PROPOSED POULTRY UNIT, CAE MOR FARM, LLWYNMAWR
Planning ref: P/2015/0810

CAE MOR PROPOSED POULTRY UNIT

Map showing proposed unit and
nearby recorded private water supplies

Fig 1: extract from 1873-5 OS map

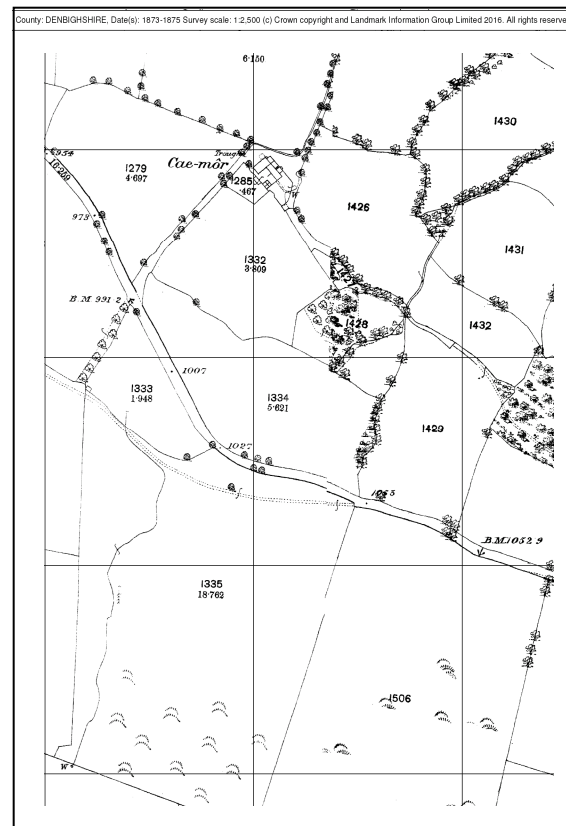
The line of possible culvert indicated on the plan provided by the Flood Officer appears to join a 'sinks' at Cae Mor Uchaf farm (fed by a small stream arriving from further uphill) with a 'spring' in the woodland below the field for the proposed poultry unit, suggesting that a continuous watercourse originally followed this route. It is understood this plan originates from an automated process which aims to 'join up' disconnected watercourses shown on mapping, rather than from site survey information. The straight line on the plan suggests this is indeed the case.

An inspection of 1:2,500 scale historical mapping for 1873-5, 1899, 1912 and 1975 provides no indication of the existence of a former watercourse following the route shown. The oldest OS map, shown in Fig 1 below, suggests that the stream originally veered westwards in the vicinity of Cae Mor Uchaf, perhaps feeding the stream flowing down the side of the lane descending to Cae Mor farm.

This does not entirely preclude the possibility that a land drain was laid across the field prior to 1873, however. It is therefore recommended that, as a precaution at commencement of construction, a slit trench is excavated across the supposed line of culvert. If an old land drain were encountered, this could then be diverted around the proposed poultry unit.

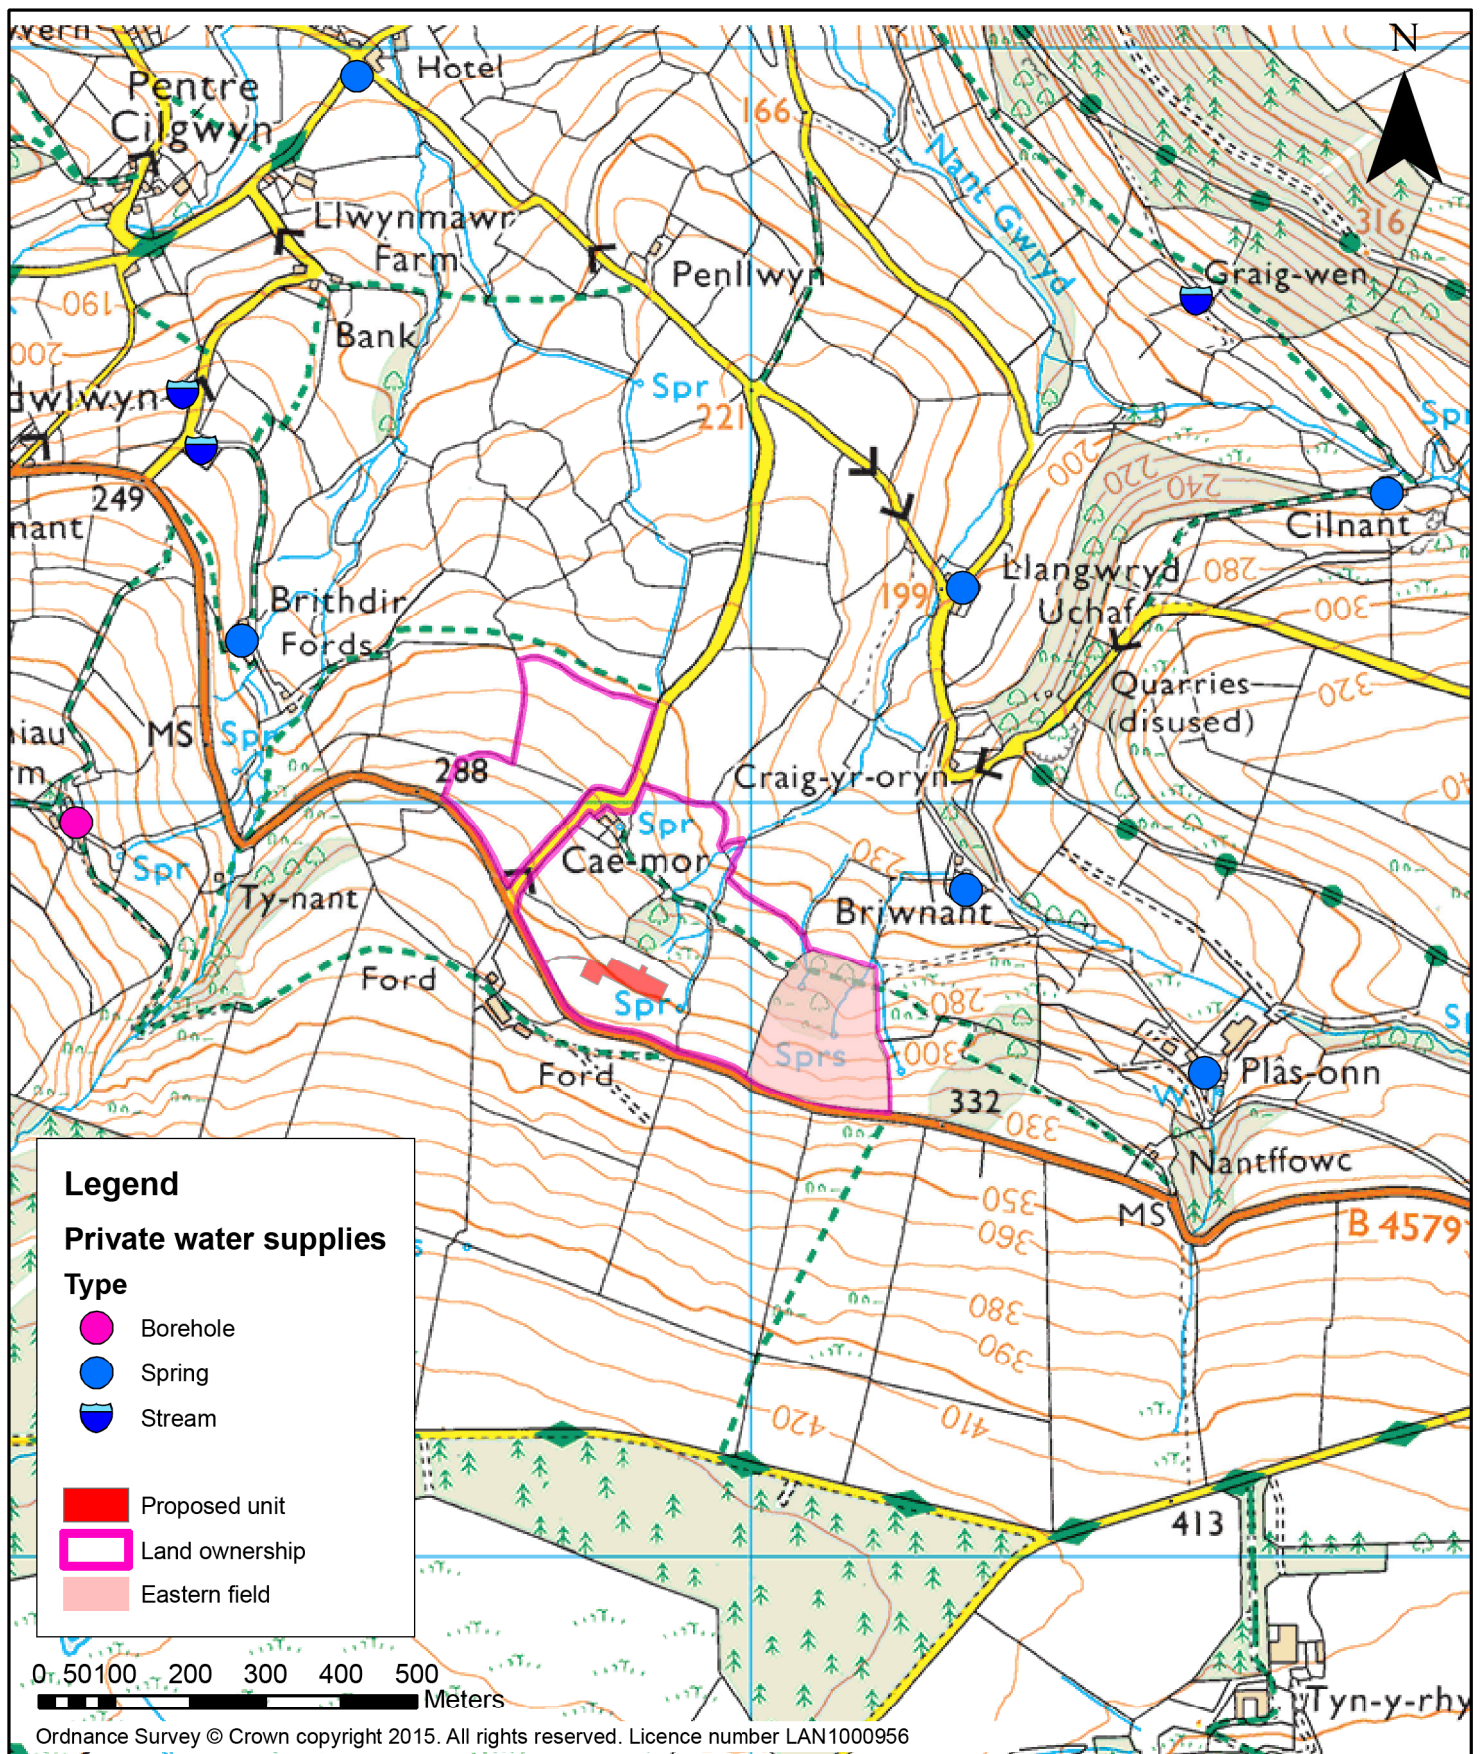
The supply locations may refer to the property or the supply itself and have not been checked on the ground. The recorded locations are plotted on the attached plan, in relation to the proposed unit and the land ownership at Cae Mor farm (it is assumed that the land to the west of the lane at Cae Mor farm would not be used for poultry). The only supplies whose surface-water catchments could conceivably be impacted by contamination at Cae Mor are those at Briwnant and Llangwryd Uchaf and further consideration is given to these.

The supply at Llangwryd Uchaf is described as a spring. A spring at this location, near the foot of a steep westward-facing slope, is likely to draw its water from higher ground immediately to the east, rather than from the Cae Mor area.

The supply at Briwnant is also described as a spring, with a likely catchment area being the slope to the south. It is conceivable that the catchment extends into the easternmost part of the land holding.

If the mitigation measures in Table 2 are implemented, and provided that the eastern field (shown shaded on the plan) is protected from development (apart from low-moderate intensity scratching) then risks to private water supply springs at the given locations are unlikely to be significant.

If these conditions cannot be met, it is still possible that risks are insignificant, but further assessment would be needed to prove it.
